Second Response to Issues raised on the NHM-10X FCC Application

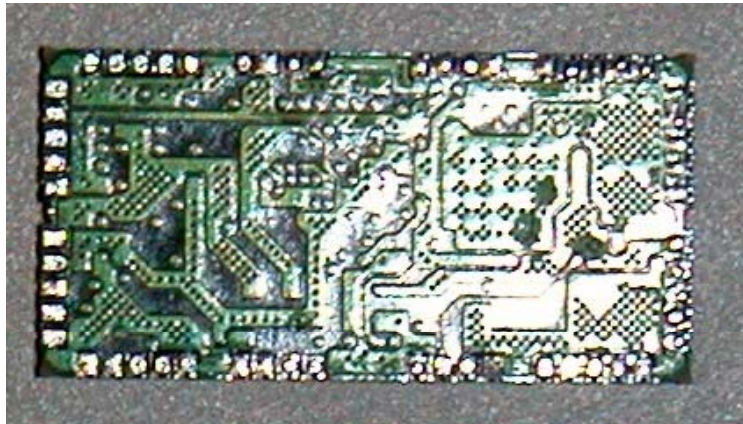
1) We did not realize that the Bluetooth was a installed module. Part 15 (bluetooth approval) requires the top and bottom of each board photographed. Please provide an additional bottom photograph of the module.

Response 1) As requested, an image of the underside of the Bluetooth Module is shown below.
